February 5, 2018

**Re: Comments on the Draft Environmental Impact Statement/Environmental Impact Report for the Ballona Wetlands Restoration Project; Support of Alternative 1 with modifications**

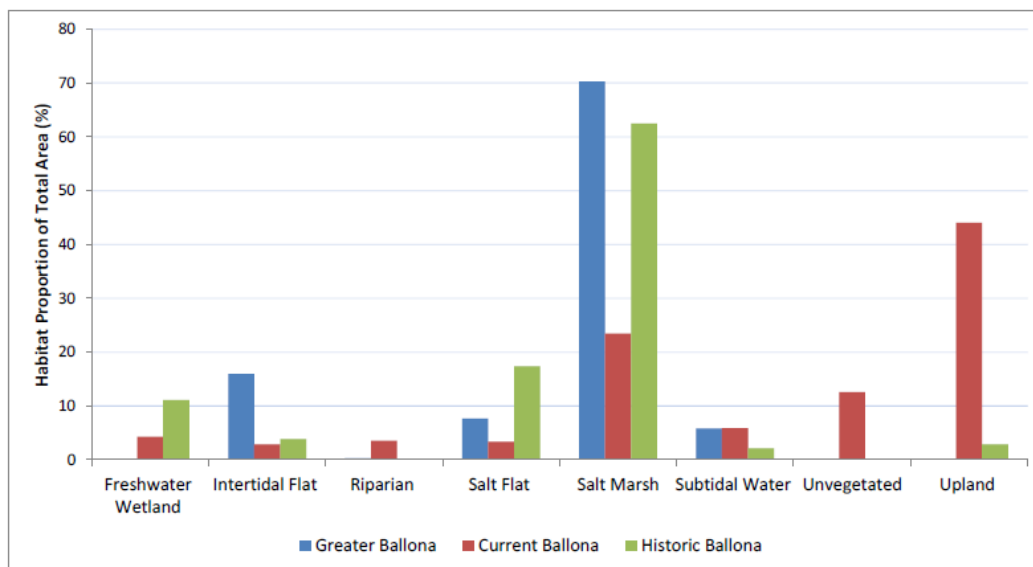
It is possible and appropriate to use the known historical ecology of the Ballona Wetlands and other coastal California wetlands as a basis for setting overall habitat restoration goals. For instance, the Ballona Creek Wetlands EPA TMDL for sediment and invasive exotic vegetation<sup>9</sup> sets objectives based on historic elevation ranges and habitats at Ballona Wetlands and similar wetland systems in Southern California. The TMDL relied upon credible sources such as the historical T-sheet map<sup>10</sup> for the Ballona Wetlands as well as historical ecology studies<sup>11</sup>. The Draft EIR/S acknowledges the Ballona Wetlands TMDL and while the restoration alternatives do not explicitly meet all the load allocations set in the TMDL, the Draft EIR/S uses dual approaches to achieve sediment removal and restoration of historical tidal wetland habitats. The Draft EIR/S appropriately considers and aims for historical wetlands habitats while accommodating current and future constraints.

Further, arguments have been made for restoring Ballona Wetlands to a historical state as a predominantly freshwater wetland. However, as described above, it is not appropriate to restore any wetlands to a specific point in time without considering current and future constraints. Additionally, it is not clear that the Wetlands were predominantly freshwater. The EPA TMDL defines the Ballona Wetlands as a “tidal marsh-tidal flat dominant system”<sup>12</sup> and based on the historical ecology<sup>13</sup>, the freshwater wetlands were further inland than the extent of the proposed restoration project. The TMDL specifies that the 303(d) impairment listing is for “reduced tidal flushing” and acknowledges that compared to freshwater inputs, “...the more limiting factor, comparatively, is a significant reduction in tidal flow.”<sup>14</sup> The EPA TMDL shows a graph (copied below) of habitat proportions for Greater Ballona Wetlands Complex (1752 acres), current Ballona Wetlands, and Historical Ballona Creek Wetlands (626 acres).<sup>15</sup> The graph shows that there was some freshwater marsh in the project area historically (approximately 10%) but the primary loss of habitat compared to historical conditions is in the loss of salt marsh habitat. We do acknowledge that historically, the Ballona Creek Wetlands were typically closed to the ocean and only opened periodically during storms; however, returning to a periodically closed lagoon system is infeasible

given current infrastructure. Therefore, given current constraints and feasibility issues, future sea level rise, and historical ecology evidence, moving forward with a restoration that emphasizes estuarine tidal wetlands is the best option.
